ORIGINATION FORM

Proposed Revisions to a Standard Plans Index

Index Number: 521-650

Index Title: Light Pole Pedestal - Wall Coping

TABLE 1 DESIGN LIMITATION FOR ANCHOR BOLTS (1" Dia.)

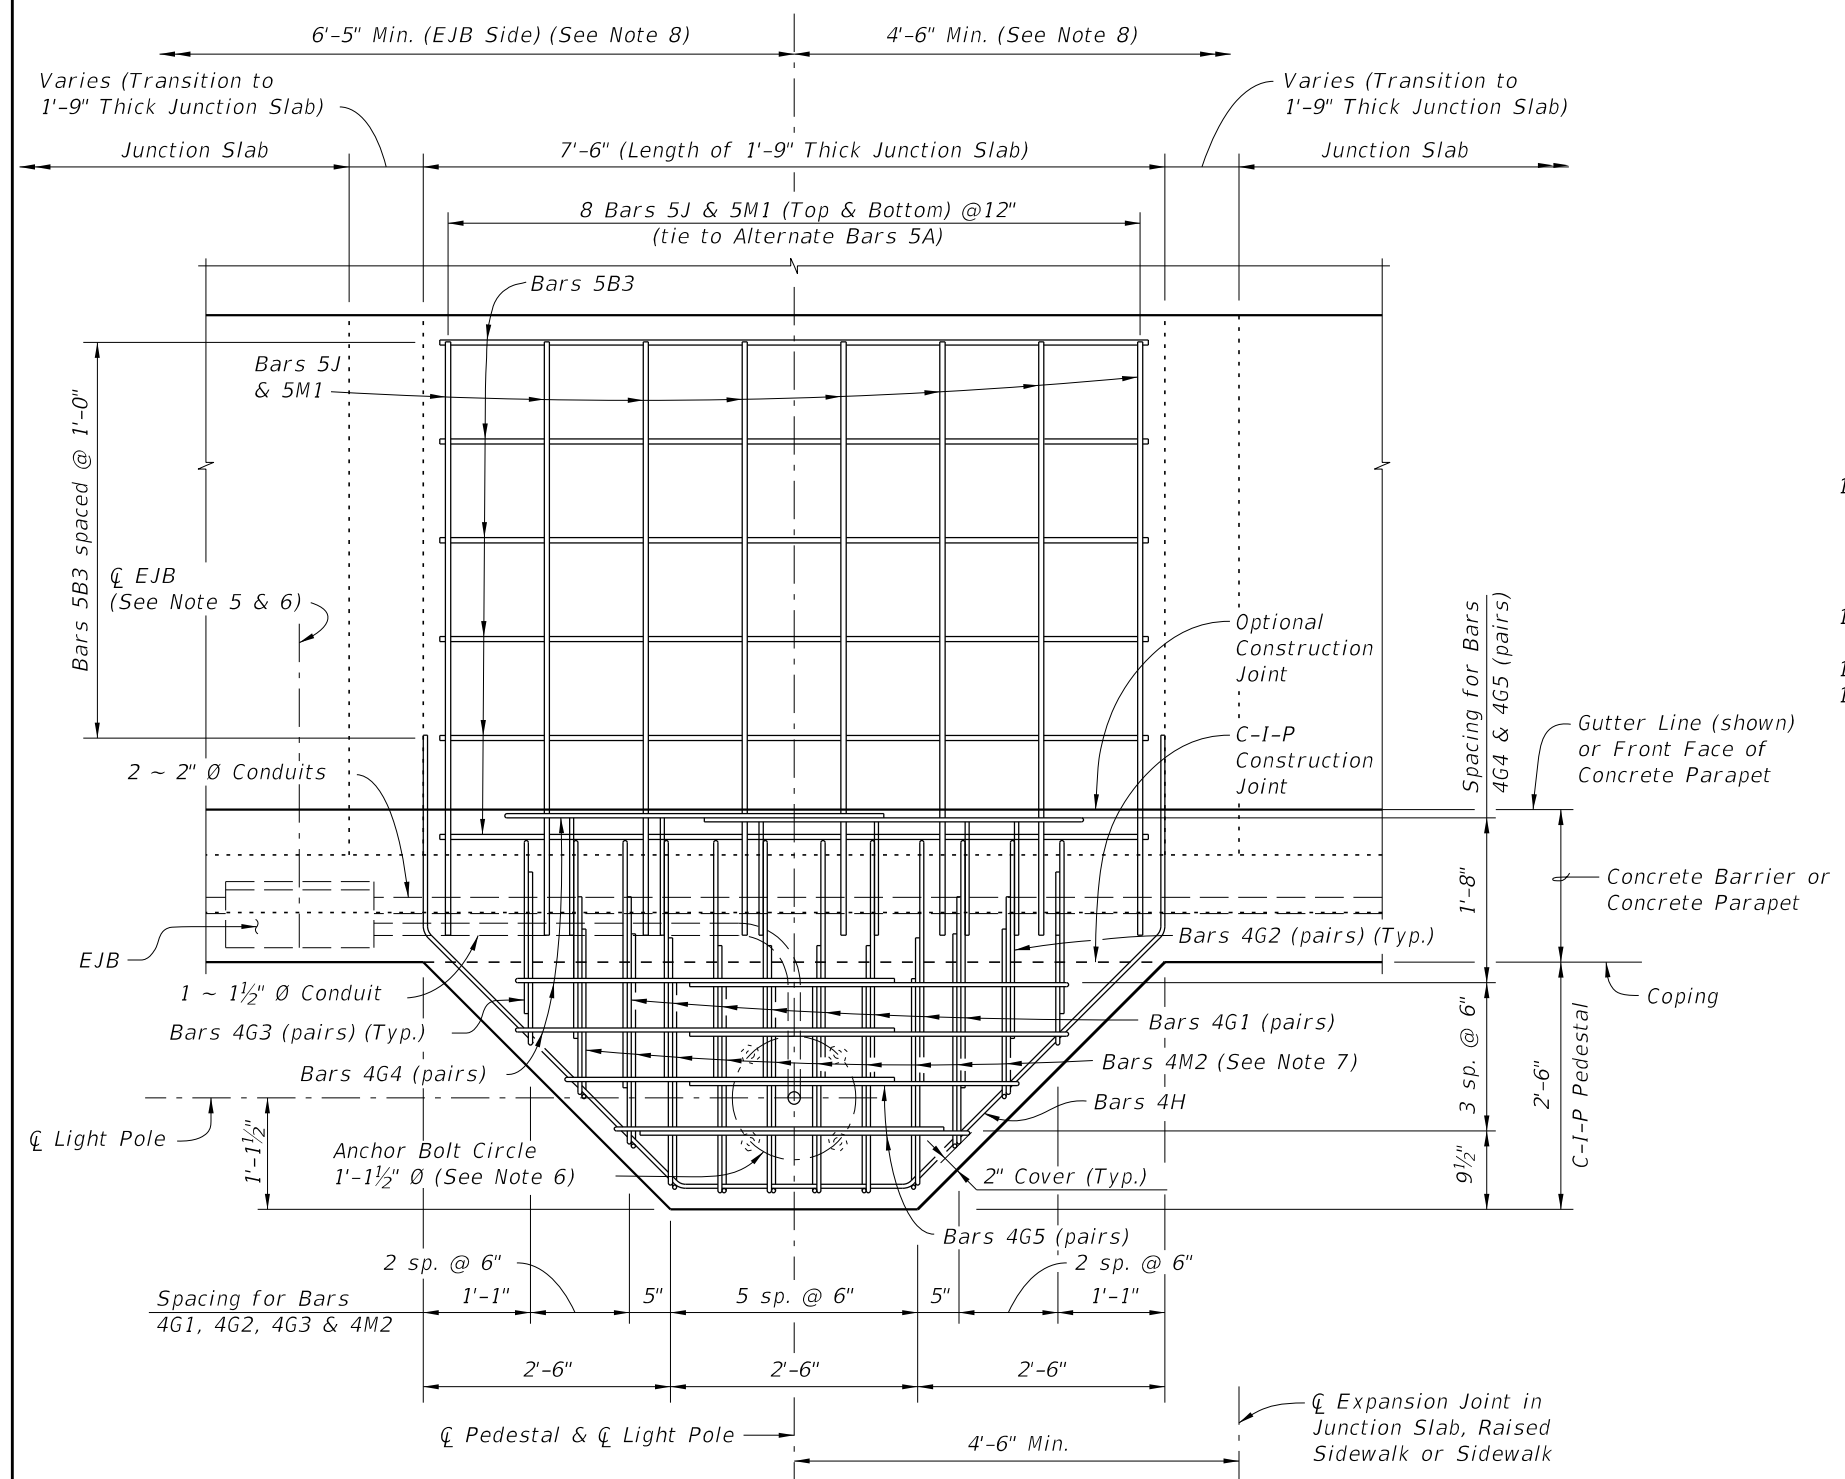
Sheet 1: Table 1 - Changed the column headings to "Top of Pedestal Height (Ft.)" and "Luminaire Mounting Height";
Note 10 - Added Index 521-611 reference

Sheet 1: The Table 1 column headings were revised to better define the height restrictions shown

Top of Pedestal Height (Ft.)*
Luminaire Mounting Height

DETAIL "A"

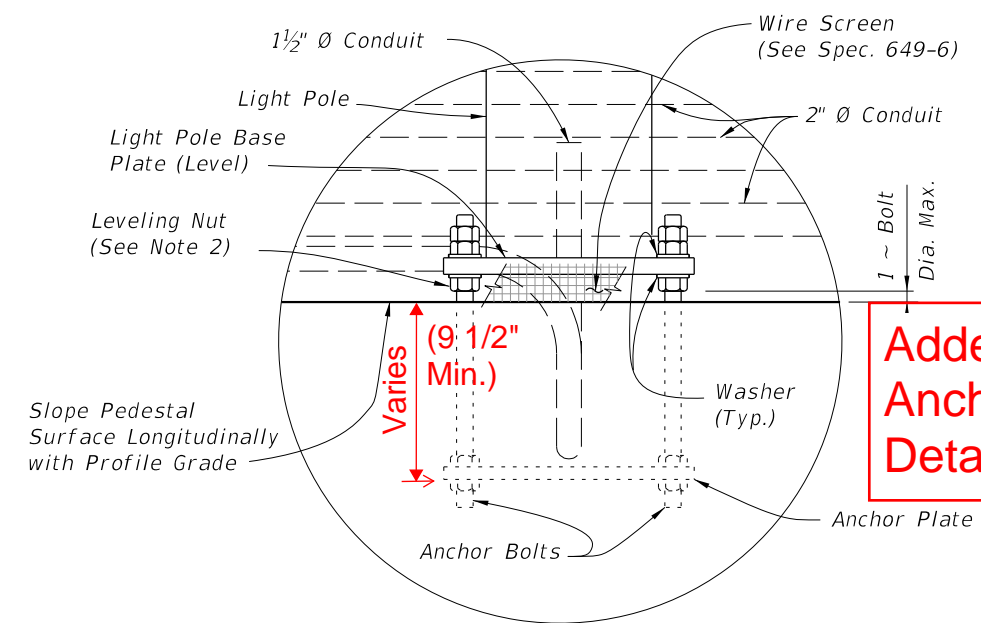
Sheet 3: Detail "A" - Added minimum depth for base plate; Added new Anchor Plate Detail

Sheet 3: More information was provided to clarify the anchor plate design and placement. The new anchor plate detail is based on Index 521-660, Sheet 4.

Added new Anchor Plate Detail

➔ Moved Here
